SYSTEM SUPPORT DIRECTIVE

ASR9

SDR-ASR9-009

**UPDATE PAGES TO
TI 6310.25**

Figure 7-3. Trigger Amplifier A11 Pre-Installation Checks Waveforms

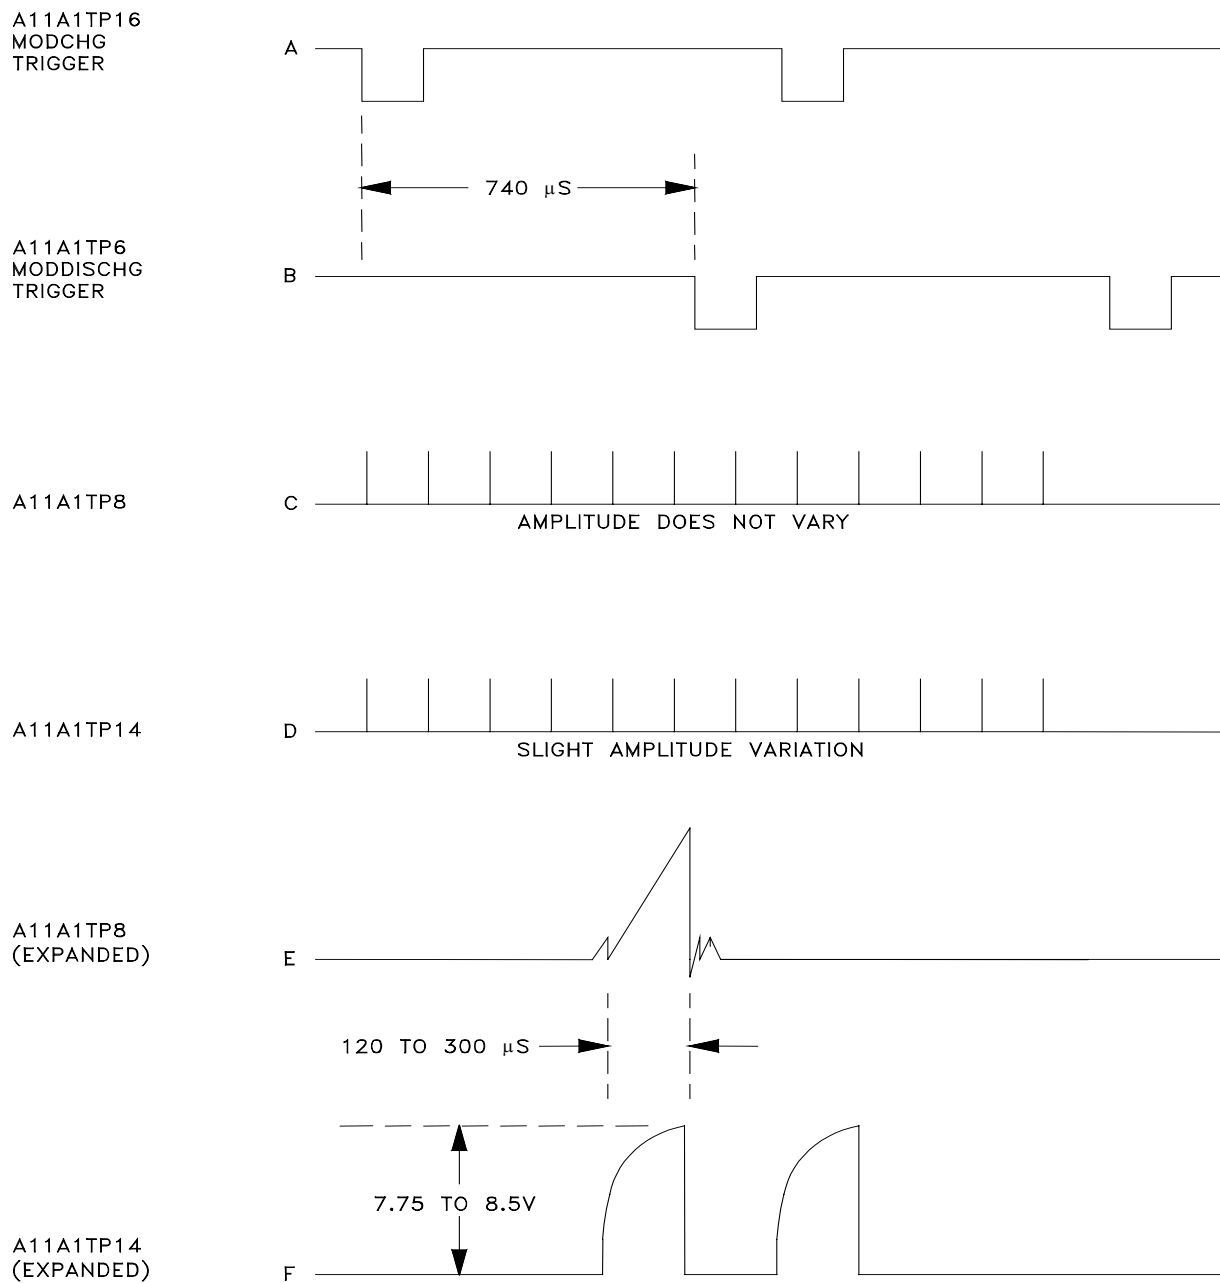
6. Power on trigger amplifier and observe A11 test points:
 - a. Synchronize oscilloscope at CPI PR START jack (J6) on target i-f panel assembly A1 in Radar Receiver/Processor Channel A/B (Unit 2/5). Connect oscilloscope channel A input to A11A1TP16 and connect oscilloscope channel B input to A11A1TP6.

- b. Turn on AUXILIARY POWER circuit breaker CB2 and HIGH VOLTAGE POWER circuit breaker CB1.
 - c. At trigger amplifier A11, observe trigger spacing of 740–microsecond interval from start of the charge trigger at A11A1TP16 to the start of the discharge trigger at A11A1TP6.

- d. Turn on high voltage, after preheat is completed.
 - e. Expand triggers for a presentation with no jitter or lines going through presentation as shown in figure 7-3, examples A and B.

- f. Look for a clean, open waveform on both test points for a one–minute period.
 - g. Turn off high voltage.
7. Observe trigger amplifier A11 test points A1TP8 and A1TP14:

- a. Set oscilloscope for 2 milliseconds sweep time.
 - b. Turn on high voltage.
 - c. Observe the primary current (A11A1TP8) and RBDT stack voltage (A11A1TP14) for uniformity in voltage as shown in figure 7-3, examples E and F.

- d. Expand waveforms E and F as shown in figure 7-3.
 - e. Monitor A11A1TP8 and A11A1TP14 for 30 minutes with high voltage on.
 - f. Observe A11A1TP14 for minimal droops at the trailing edge (discharge time). Both waveforms should show consistency from pulse to pulse.

- g. If any discontinuity exists in waveform at A11A1TP8, then a possible defect exists in the trigger amplifier under test or the synchronizer.
 - h. If any discontinuity exists in waveform at A11A1TP14, then a possible defect exists in the trigger amplifier under test or the charging switch.
 - i. Turn off HIGH VOLTAGE.
8. Turn off HIGH VOLTAGE POWER circuit breaker CB1 and AUXILIARY POWER circuit breaker CB2.
9. Remove the trigger amplifier under test and verify the front–to–back resistance of RBDTs (greater than 5:1).
10. Reconnect cable W5P2 (removed in step 3) to A12J3 located on top of modulator pulse assembly. Install previously removed Charging Switch A10.
11. If no problems were encountered during this testing, reasonable assurance exists that the trigger amplifier is ready for permanent installation using the procedure in paragraph 7.6.8.5.
